SUNDRY NOTICES AND REPORTS ON WELLS
Do not use this form for proposals to drill or to re-enter an abandoned well. Use form 3160-3 (APD) for such proposals.

BP requests to P&A the subject well.

PLUG AND ABANDONMENT PROCEDURE

Gallegos Canyon Unit #62

Gallegos Canyon Unit #62 Proposed P&A

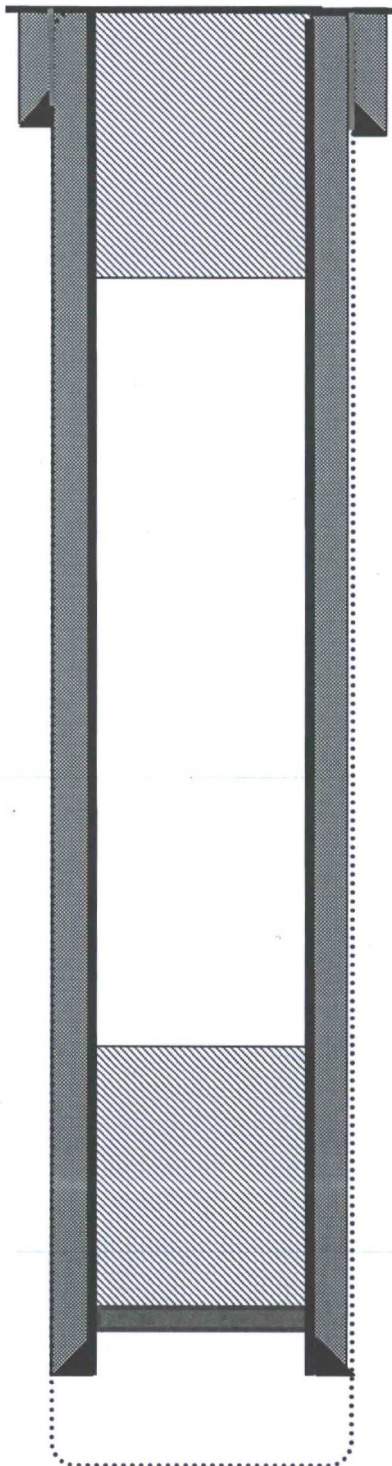
1. Plugging operations authorized are subject to the attached "General Requirements for Permanent Abandonment of Wells on Federal and Indian Lease."
2. Farmington Office is to be notified at least 24 hours before the plugging operations commence (505) 564-7750.
3. The following modifications to your plugging program are to be made:
 - a) Set plug #1 (1239 - 967) ft. to cover the Fruitland top. BLM picks top of Fruitland at 1017 ft.

You are also required to place cement excesses per 4.2 and 4.4 of the attached General Requirements.
